ADDENDUM NO. 1 ELEMENTARY ADDITION TO SUMTER CENTRAL HIGH SCHOOL

Architect Job No. 24-38 July 24, 2024 DCM # 20240619

PROJECT:	PROJECT NO.	REFERENCE:
ELEMENTARY ADDITION TO SUMTER CENTRAL HIGH SCHOOL	24-38	ADDENDUM NO. 1
ARCHITECTURAL ADDENDUM DRAWING	DATE:	SHEET NO.
ANCHITECTORAL ADDENDOW DRAWING	7/10/2024	ADD 1

1 ELECTRICAL - ROOF PLAN - PART B

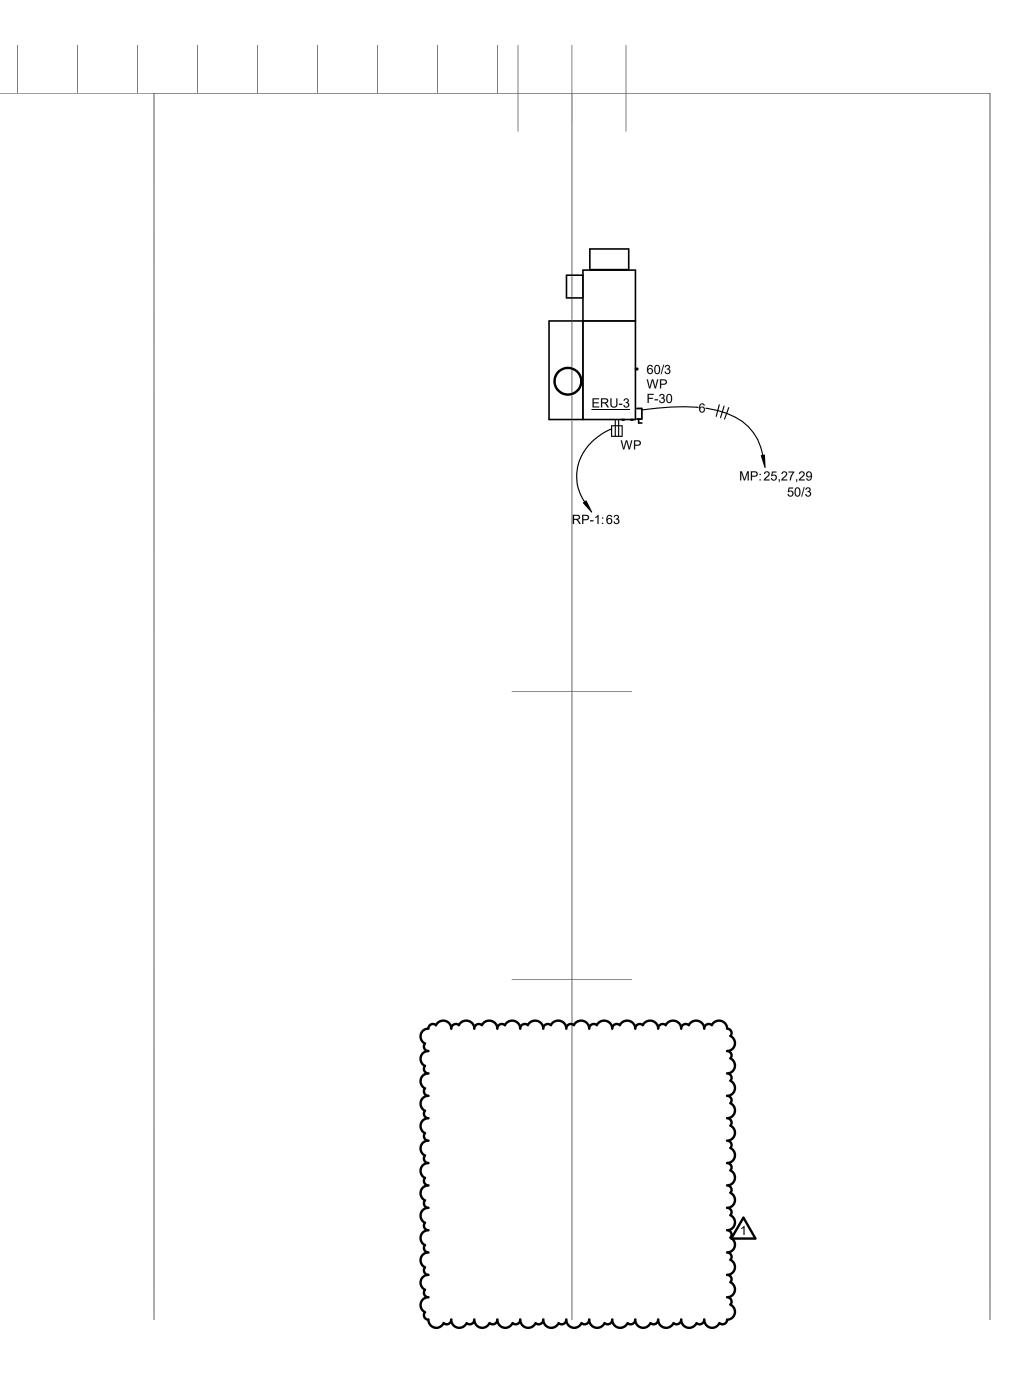
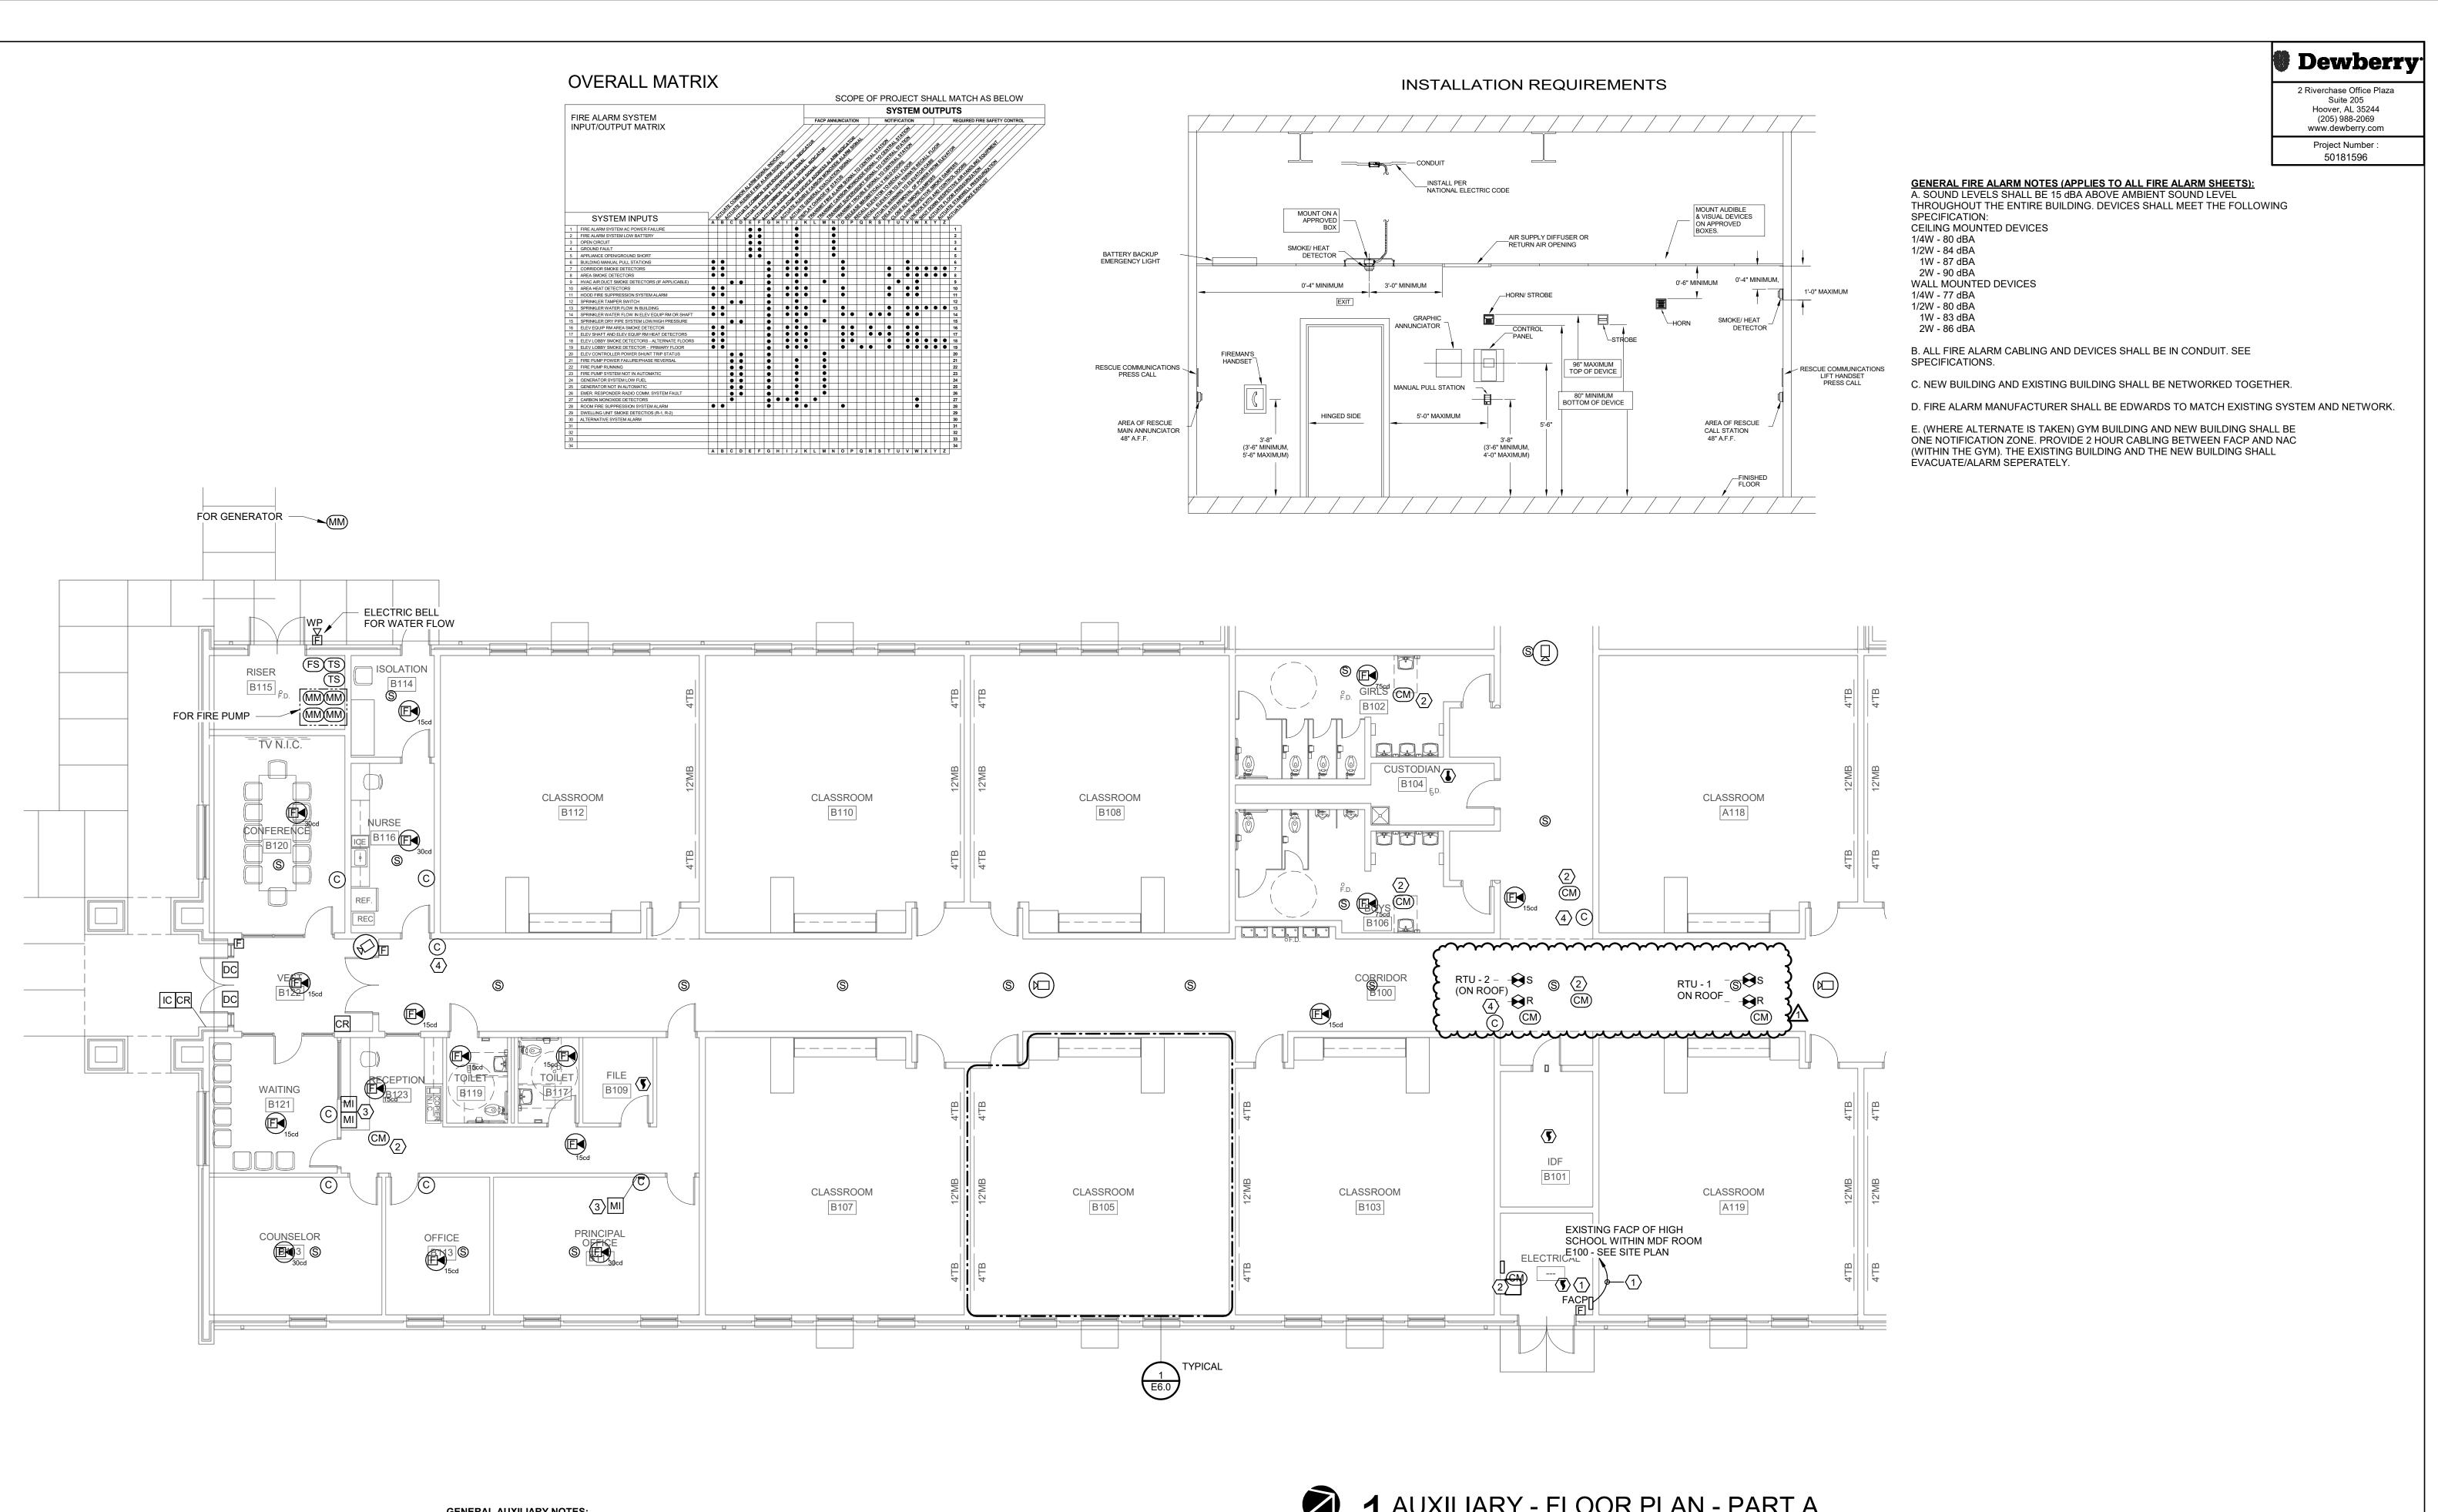
- 38. See attached Sheet **E4.0** for revisions to Electrical Roof Plan Part A.
- 39. See attached Sheet **E4.1** for revisions to Electrical Roof Plan Part B.

ЈОВ NO. **24-38** SHEET NO: E5.1

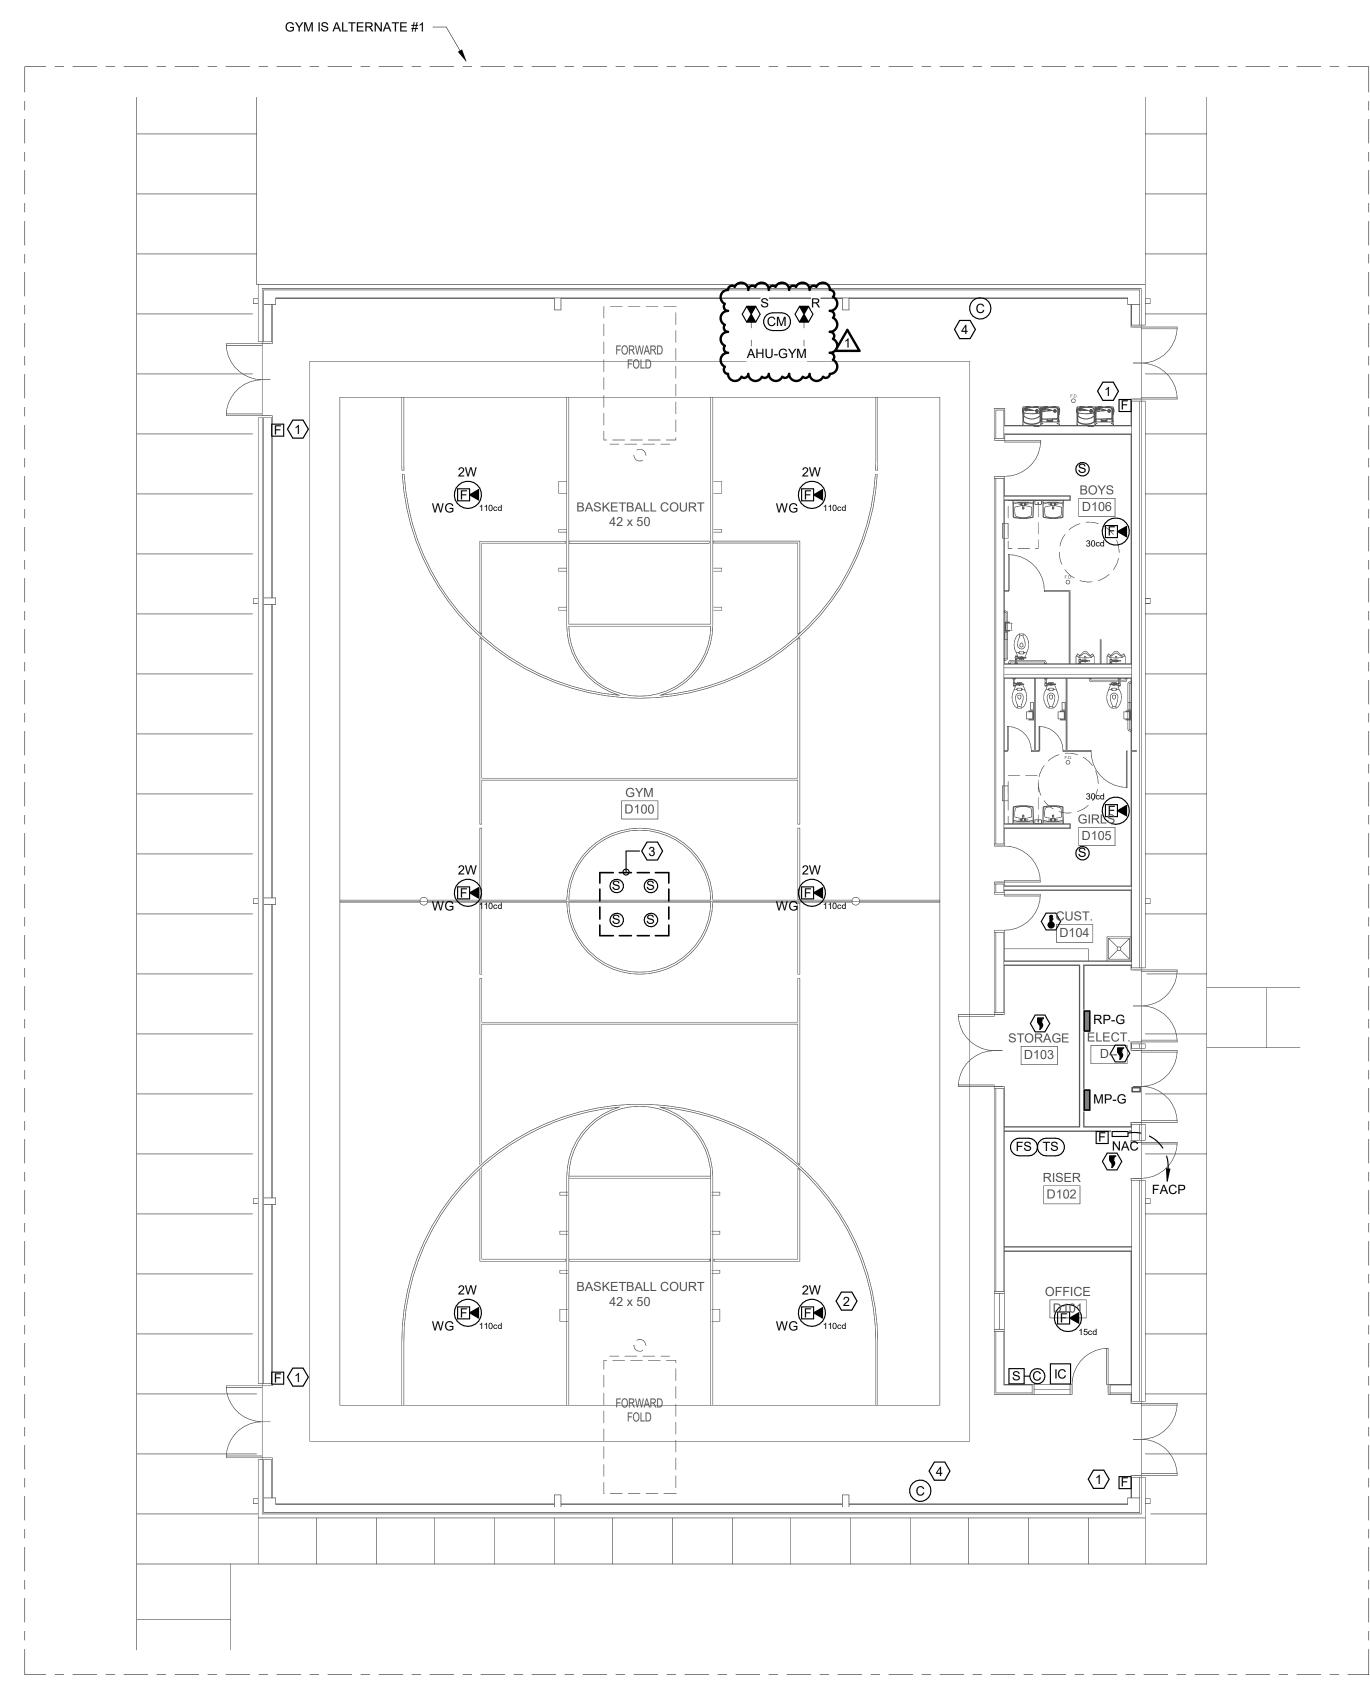
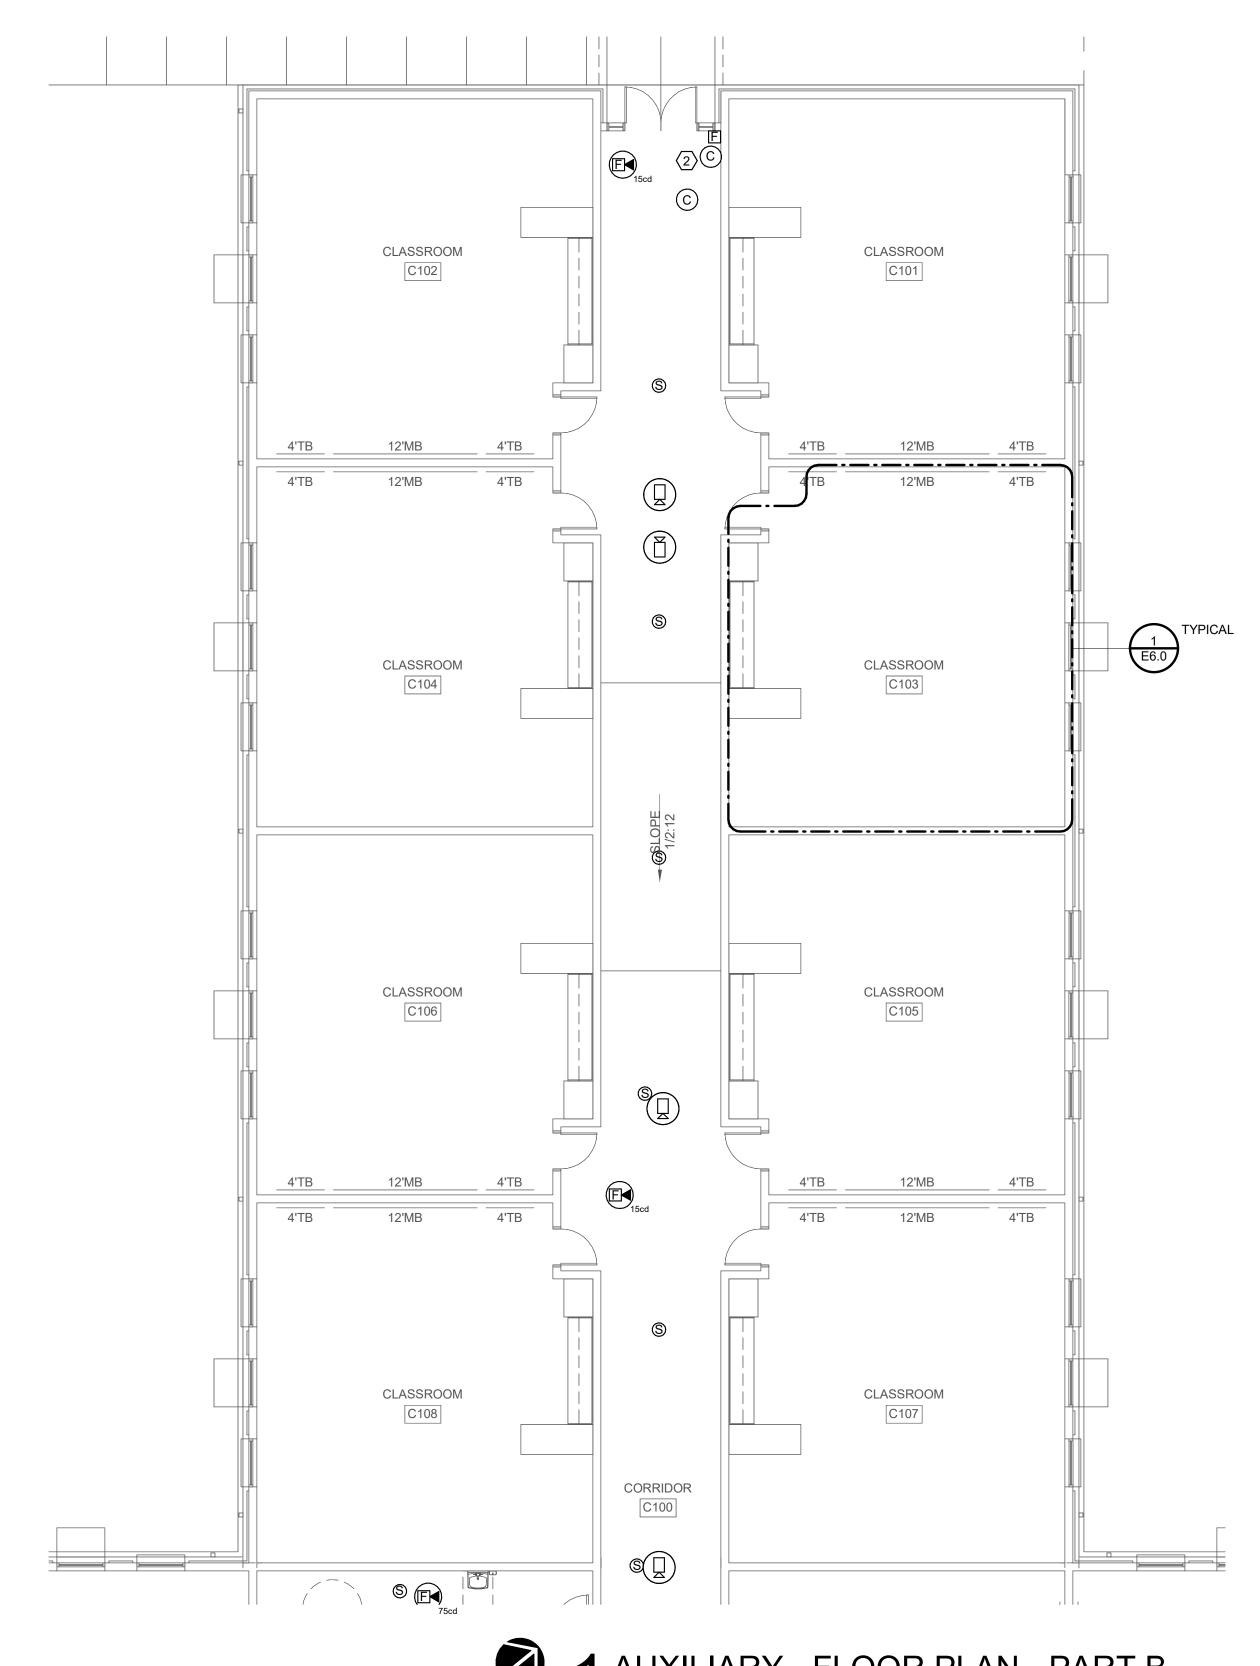
- 40. See attached Sheet **E5.0** for revisions to Auxiliary Floor Plan Part A.
- 41. See attached Sheet **E5.1** for revisions to Auxiliary Gym Floor Plan and Auxiliary Floor Plan Part B.
